August 25, 2009
NRC3-09-0021

Subject: Detroit Edison Company Response to NRC Request for Additional Information
Letter No. 7

**Response to RAI Letter No. 7
(eRAI Tracking No. 2651)**

Figure 1 – TLD Locations on Fermi Site
(following 1 page)

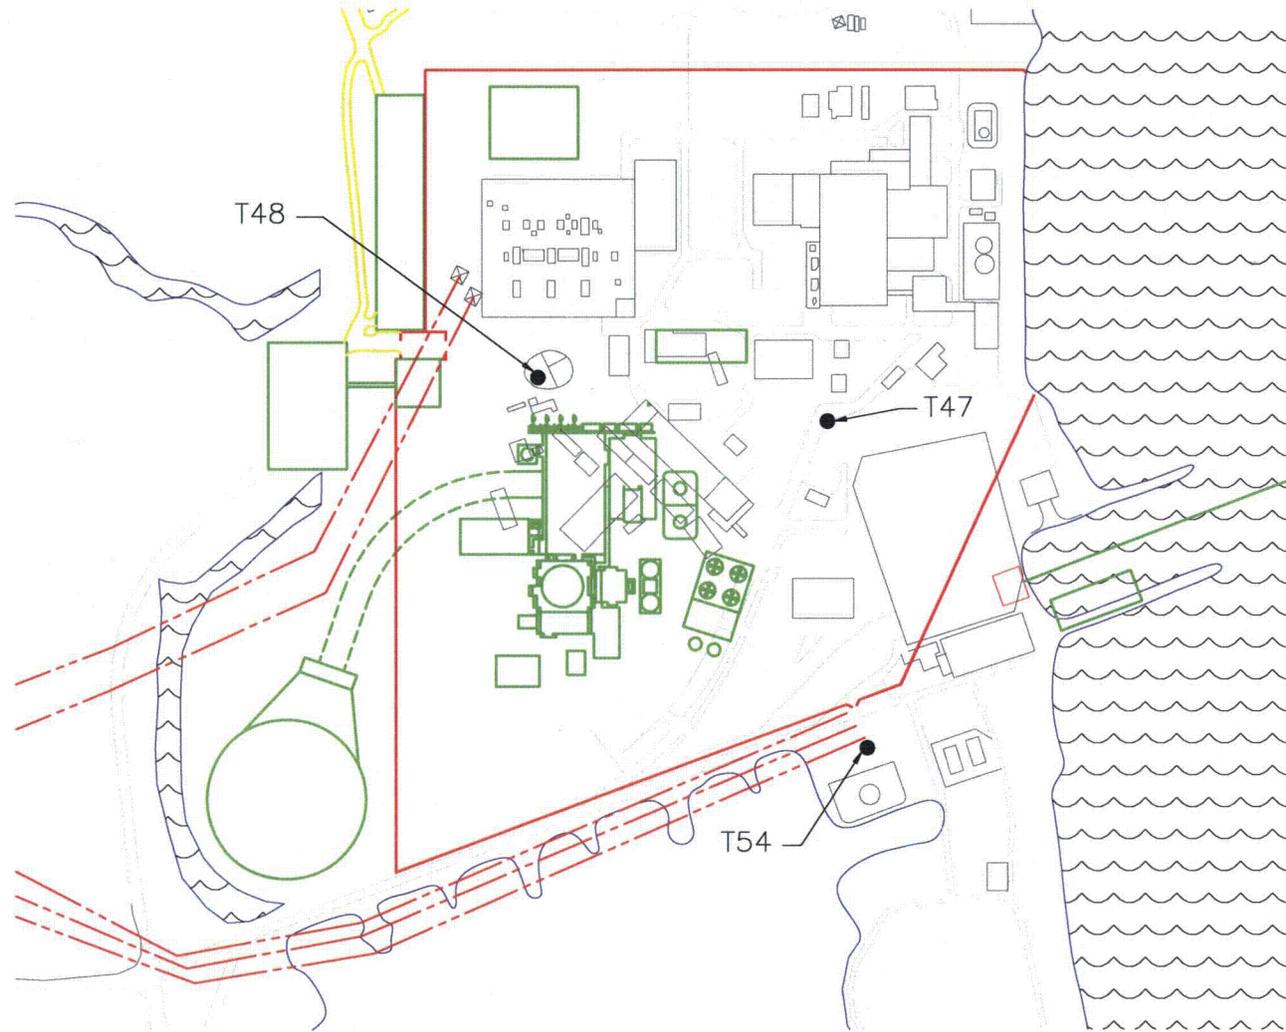
Section 12.4 of the EF3 COLA refers to the EF3 Environmental report for dose to Construction Workers. Upon reviewing the Construction Worker Dose, as reported in Section 4.5 of the EF3 Environmental report, it was noted that additional information should be included in Section 12.4 of the COL:

- specific construction activities and the number of workers used in construction worker dose calculations.*
- effects of future decommissioning activities of Fermi 1 on Fermi 3 construction worker dose.*
- plans for radiological monitoring of the Fermi 3 construction site to verify construction worker dose calculations.*

Examining the Fermi 3 site plan arrangement, ER Figure 4.5-1, and the location of the monitoring TLDs for Fermi 2, ER Figure 4.5-2, shows that there are three TLDs locations that could be used to obtain exposure rates for use in whole body dose calculations for Fermi 3. TLDs T47, T48, T54, Fermi 2 and Fermi 3 are shown together on Figure 1 of this response (see Figure 1 of attached Enclosure 1). TLDs T47, T48, and T54 are outside the Fermi 2 secure operating area, monitor areas accessible during construction activities at the power block portion of the site, and would conservatively represent exposure rates for construction activities at the south end of the site.

Of the three, TLD 48 was selected to represent dose levels for construction activities. TLD T54 is the farthest location from Fermi 2 and as such it would not be conservative to use the TLD T54 exposure rate as representative for whole body dose calculations for the power block construction site. Although the dose rate for TLD T47 is the highest of the group, its location is just outside of the Fermi 2 protected area and well removed from the eventual location of the Fermi 3 structures. Further it is not reasonable to assume that power block construction workers would spend significant periods of time in this area as it is well removed from the Fermi 3 power block construction area.

TLD T48 is closest to the Fermi 3 power block construction area, and is also located at one of the shortest distances between Fermi 2 and the Fermi 3 power block construction site. Therefore, TLD T48 provides a reasonable location to develop a representative dose for the Fermi 3 site construction workers.
